Case Officer: Lesley Porteous  
Application number: 22/00210/FUL  
Application address: 20 (3a) Woodburn Terrace, Edinburgh

We are writing to you in relation to the planning application reference 22/00210/FUL (20 (3a) Woodburn Terrace, Edinburgh).

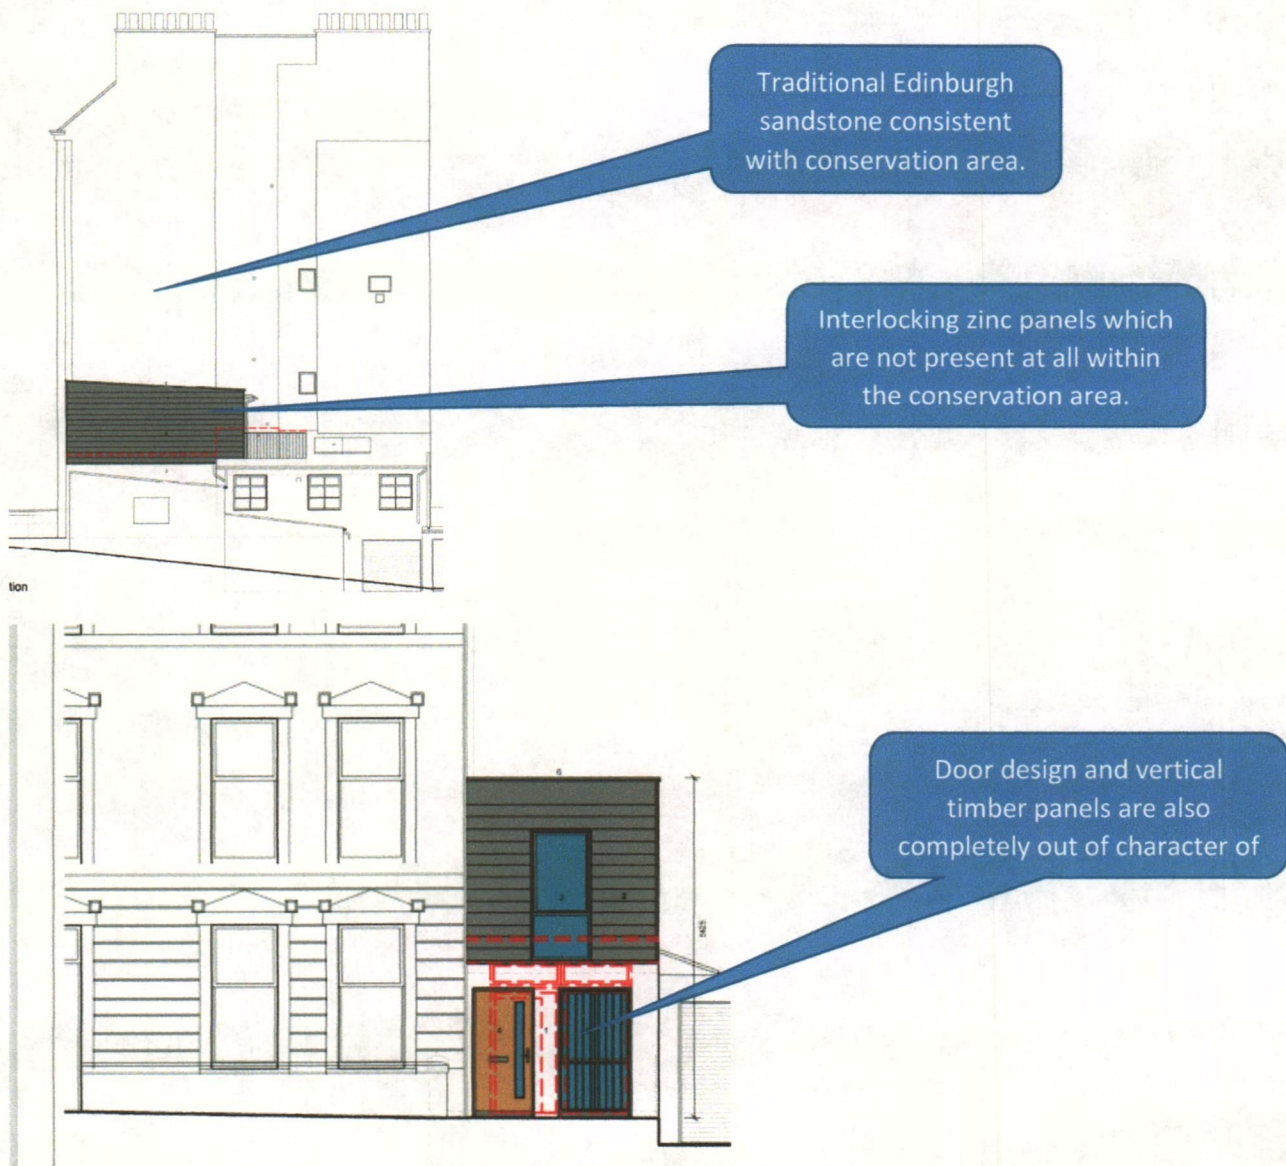
None of the proposed materials (above) are in any way consistent with existing materials in the area so do not in any way *'...protect those features that give the conservation area its special character.'*

We also object to the plans on the basis of **their design and appearance**, which are not consistent with the architectural characteristics of the street/the area. Whilst we can understand that time moves on and architectural style/fashions change (there are some examples in the centre of town), the plans above represent a building that is completely incongruous to the very nature of our area. This **new 1<sup>st</sup> floor structure** in interlocking Zinc (overlooking our private front garden) is simply – in our view – shocking in design. It does not fit with the adjoining sandstone Victorian building, with anything in our street or anything in the immediate conservation area. In addition to the incongruous shape of the proposed structure, we would like to call out the fact that the grey finish and wooden and zinc material that is being proposed within the plans are not in line with the following requirements: *'traditional materials should be used in repair and new build'* and *'alterations or additions should be sympathetic to the original style and of an appropriate scale'*. (Source: *ibid*).
